TO: William Evans, Dan Crawford, and Jan Shawyer, Port of Tacoma  
FROM: Grant Hainsworth and Nicole Ott, CRETE Consulting Inc.  
PROJECT: 1940 E. 11<sup>th</sup> Street (former Brown & Haley)  
SUBJECT: Review of RI and FS Documents  
DATE: January 8, 2014

Figure 1. 1934 Nautical Chart.

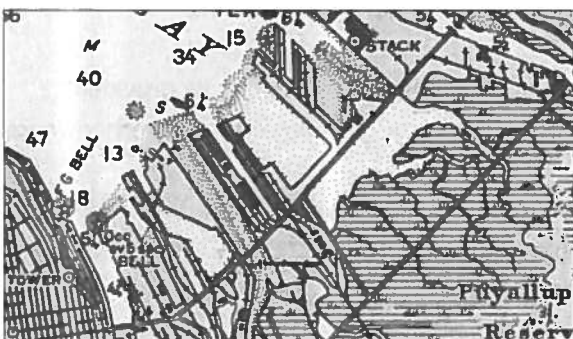
East 11<sup>th</sup> Street was originally constructed in the late 1800s and early 1900s as a thin strip of filled land connecting Marine View Drive to Downtown Tacoma via the Murray Morgan Bridge. In the vicinity of the subject site, tidal water was present on both sides of the roadway until at least 1934 (Figure 1). A 1943 drawing describing widening of East 11<sup>th</sup> Street shows a pre-existing bulkhead on the southeastern side of the existing road and constructed backfill at a 2:1 slope extending further to the southeast (Figure 2). To date there has been no investigation of the 11<sup>th</sup> Street embankment, underground utilities within the road right-of-way, or other features in that area which may be influencing local hydrogeology.

Figure 2. 1943 11<sup>th</sup> Street Widening Section

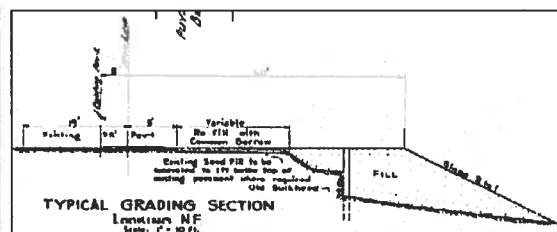
The nature of the fill placed to construct East 11<sup>th</sup> Street may also be having an effect on groundwater flow toward the Sitcum Waterway. If the fill is gravel/rock, groundwater may flow through unimpeded. However, if the road fill is relatively dense wood waste and/or fine grained soil, the embankment may be functioning as a dam, diverting shallow groundwater flow to the northeast or southwest.
